UNITED STATES PATENT AND TRADEMARK OFFICE

APPLICATION NO.	FILING DATE	FIRST NAMED INVENTOR	ATTORNEY DOCKET NO.	CONFIRMATION NO.
09/680,277	10/06/2000	Je Hong Kim	2658-0242P	8486

Office Action Summary

DETAILED ACTION

FIG. 1

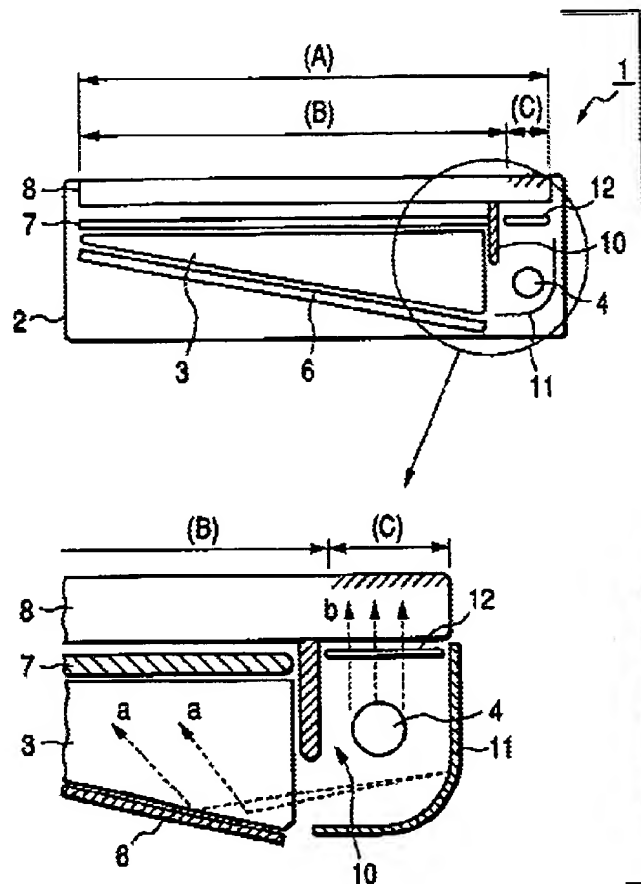
Matsushita teaches in the first embodiment, Figure 1, the use of a light input device wherein a light shielding plate, 10, is disposed so that part of the light emitted from the linear light source and reflected by the reflecting plate, 11, is condensed

(Applicant's high focusing) at the end portion (col. 6, lines 22-29) of the light conduction plate, 3 (Applicant's light guide), in order to improve display visibility so the LCD can be formed as a vehicle-mounted alarm display device for displaying various alarms (Abstract). As can be seen in Figure 1, the light is substantially directed to a rear side of said light input device in a direction away from the light guide prior to directing said light path to a front side thereof and toward the light guide to obtain high focusing of the light beam.

Matsushita is evidence that ordinary workers in the art of liquid crystals would find the reason, suggestion, or motivation to add a light input device wherein a light shielding plate is disposed so that part of the light emitted from the linear light source

FIG.4

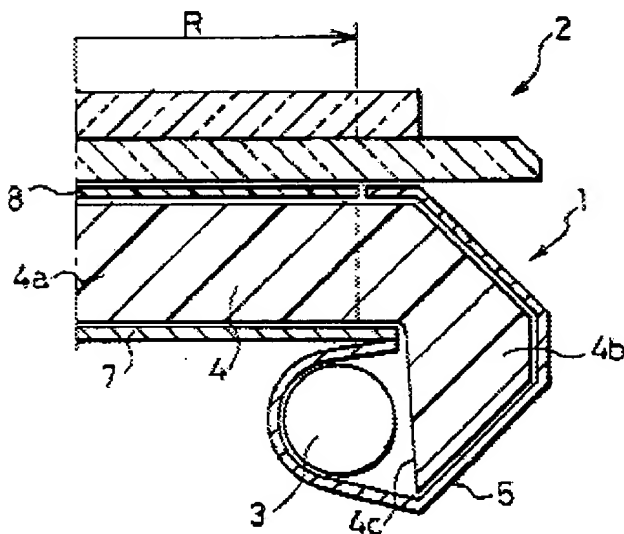
Oyama teaches in Figure 4 a light unit comprising a light-guide plate, 4a, and a reflector, 5, having a sectional view of spiral shape that efficiently guides the light (Applicant's high focus) from the light source to the light guide plate (col. 6, lines 13-24).

Oyama teaches in Figure 4 a light-guide plate, 4a, installed at height different from the light, 3, input to reduce the outside dimensions of the entire apparatus with respect to the area of the display space (col. 2, lines 53-60) having a sectional view of spiral shape. Note this motivation is applicable regardless of element 4b.

Oyama is evidence that ordinary workers in the art of liquid crystals would find the reason, suggestion, or motivation to add a light-guide plate installed at height different from the light input to reduce the outside dimensions of the entire apparatus with respect to the area of the display space.

FIG.14(b)

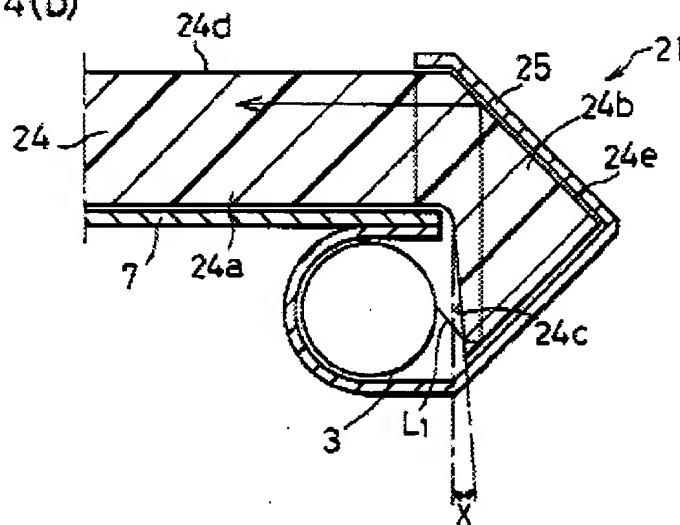
As to claim 5, Oyama teaches in Figure 14(b) a light unit wherein the reflective plate, 25, is curved to obtain a desired vertical incident angle of the light beam progressing to the light-guide plate to reduce bright lines in the display near the light source (col. 13, lines 33-52, especially lines 42-48).

Oyama is evidence that ordinary workers in the art of liquid crystals would find the reason, suggestion, or motivation to use a light unit wherein the reflective plate is curved to obtain a desired vertical incident angle of the light beam progressing to the light-guide plate to provide desired illumination characteristics.

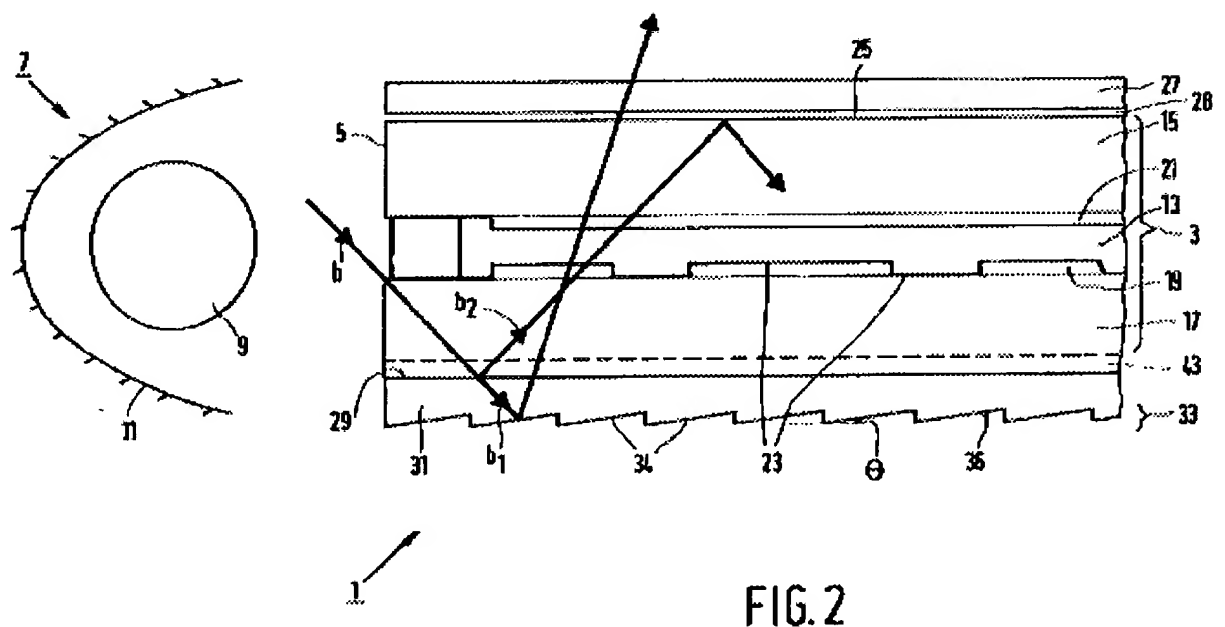
As to claim 7, Oyama teaches in Figure 14(a) a light unit wherein the lamp housing includes at least one reflective plate for cutting off the light beam progressing directly from the lamp into the light-guide plate, the at least one reflective plate being a protrusion of the inner surface of the lamp housing.

Oyama is evidence that ordinary workers in the art of liquid crystals would find the reason, suggestion, or motivation to use a reflective plate for cutting off the light beam progressing directly from the lamp into the light-guide plate, the at least one reflective plate being a protrusion of the inner surface of the lamp housing to provide desired illumination characteristics.

FIG. 7

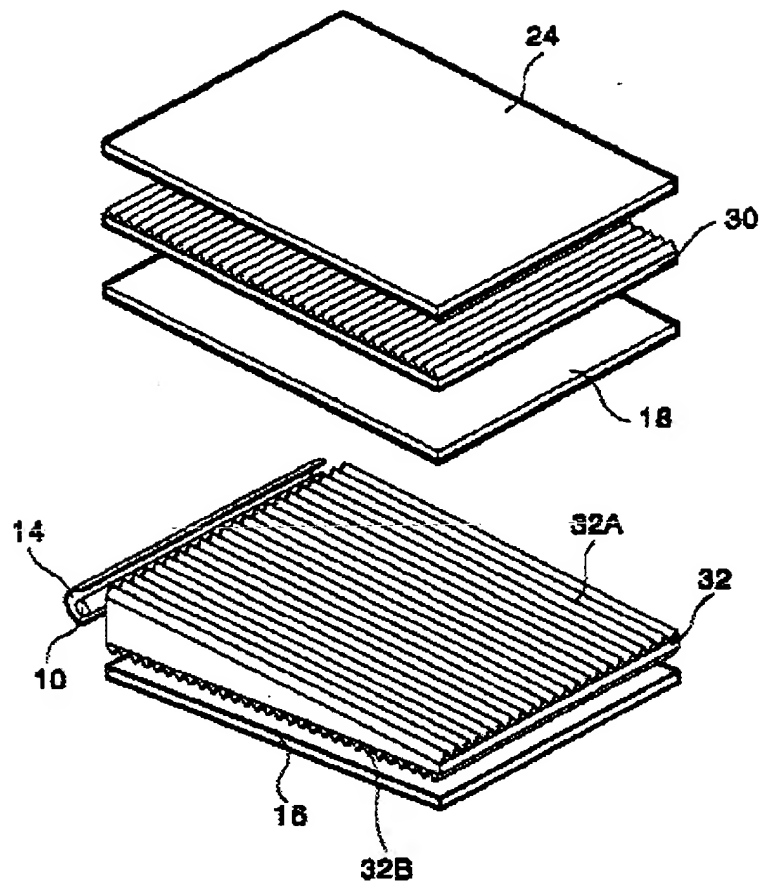
Kim teaches in Figure 7 the use of a light unit wherein the light-guide plate includes a plurality of prism patterns arranged on another surface thereof in intersection with the unit patterns.

Kim is evidence that ordinary workers in the art of liquid crystals would find the reason, suggestion, or motivation to add a plurality of prism patterns arranged on another surface thereof in intersection with the unit patterns to enhance the utilization ratio of the light generated by the lamp (col. 6, line 58 through col. 7, line 15).

FIG. 1

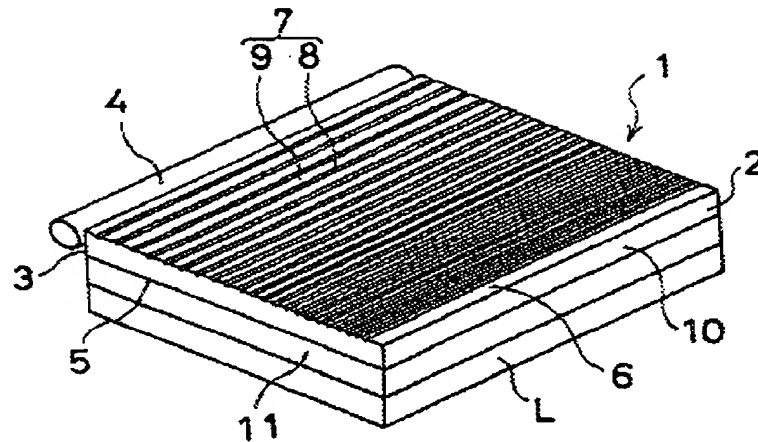
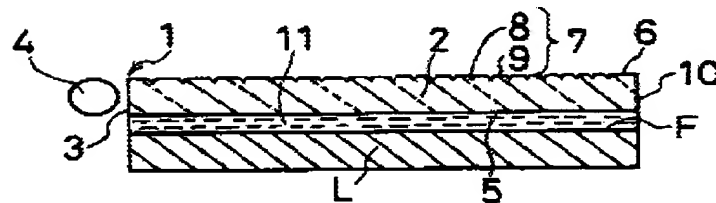
Egawa teaches in Figures 1 and 2 a light guide plate dispose on the front side of a liquid crystal panel to provide illumination without degrading contrast and without generating a moiré pattern (col. 4, lines 11-17).

Egawa is evidence that ordinary workers in the art of liquid crystals would find the reason, suggestion, or motivation to add a light guide plate disposed on the front side of a liquid crystal panel to provide illumination without degrading contrast and without generating a moiré pattern.

Egawa teaches in Figures 1 and 2 a light guide plate wherein a distance between the unit patterns that gets gradually shorter as said unit patterns get farther away from the incident side of the light-guide plate so that the brightness becomes nearly uniform at any position in the transparent substrate (light guide) without being influenced by the distances from the light source lamp (col. 12, lines 34-50).
